DUKE POWER COMPANY
OCONEE NUCLEAR STATION

PROPOSED TECHNICAL SPECIFICATION REVISION

Justification for Proposed Changes and Evaluation of No Significant Hazards Considerations

Figure 6.1-1

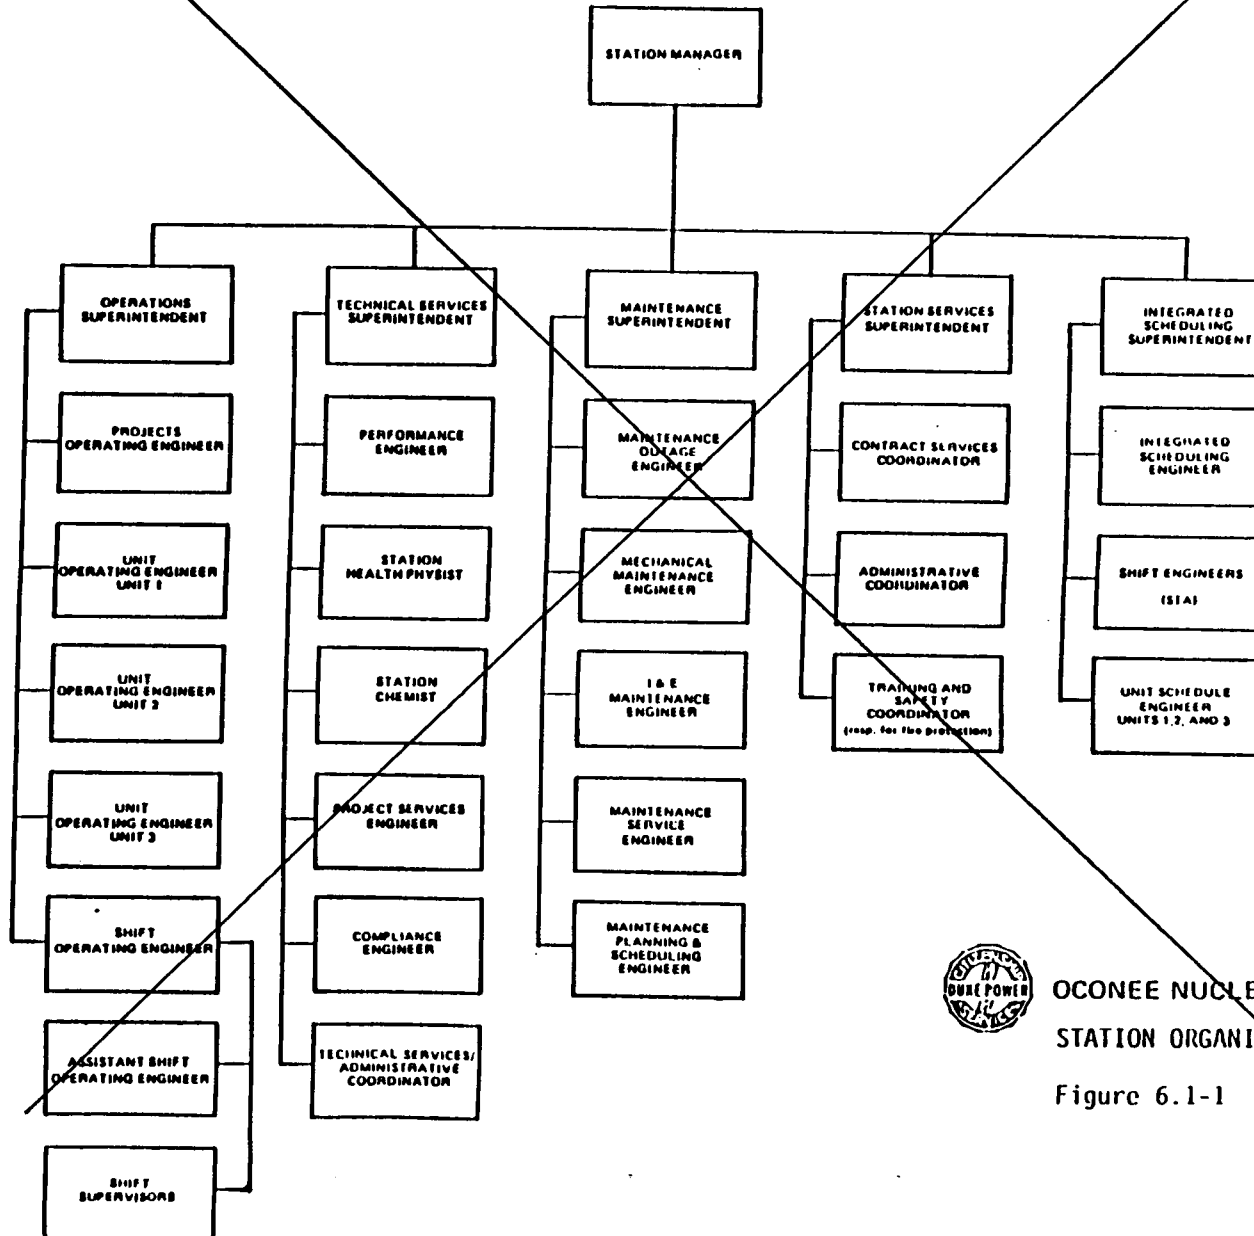
DELETE

9. Organization charts in Figures 6.1.1 and 6.1.2 are deleted per Generic Letter 88-06 guidance. The existing organization charts in Chapter 13 of the FSAR depicting the lines of authority and responsibility will be updated as necessary for any future changes to these organizations.

OCONEE NUCLEAR STATION
MANAGEMENT ORGANIZATION CHART
Figure 6.1-2

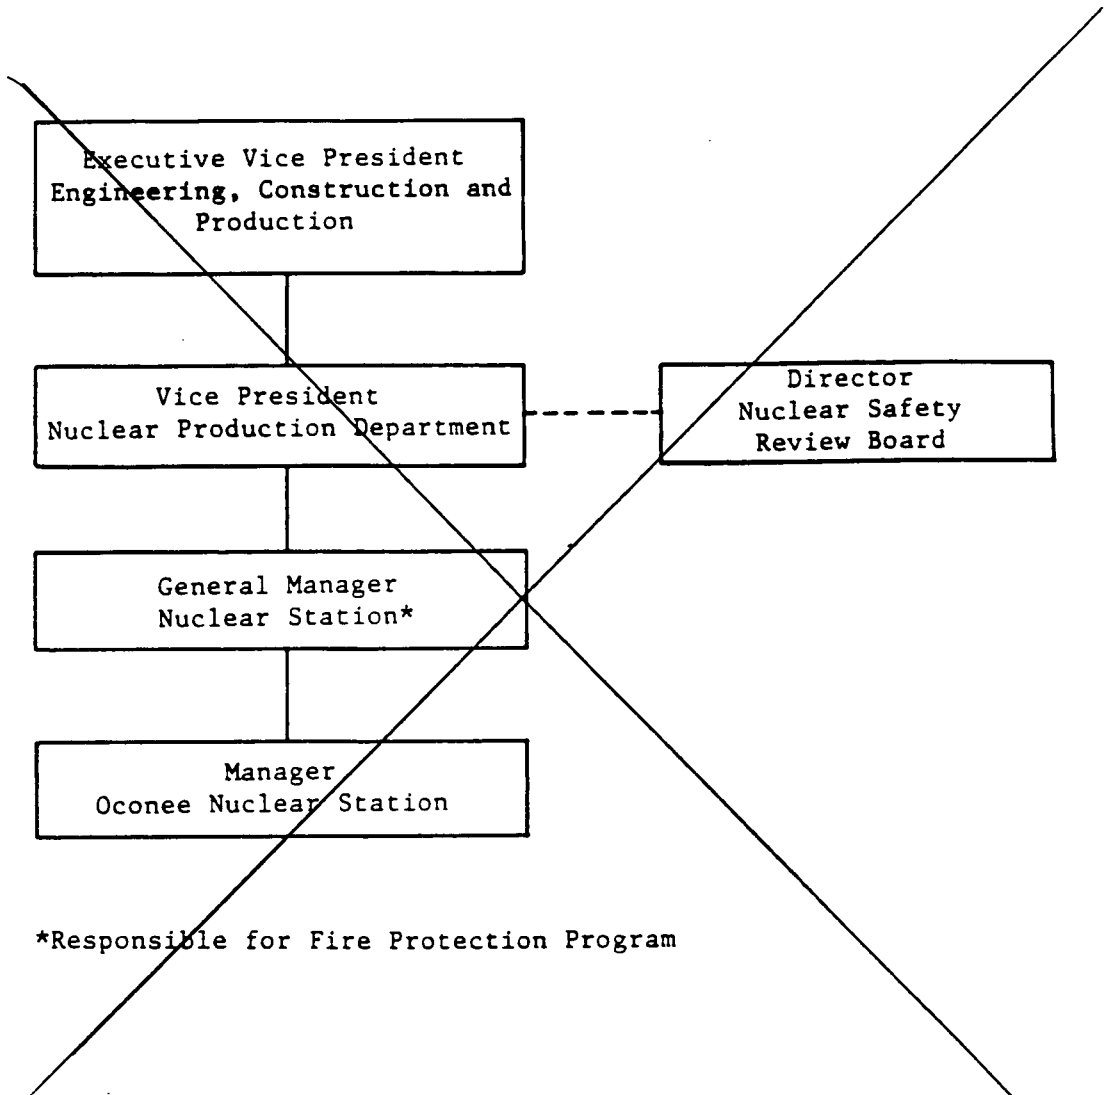
DELETE
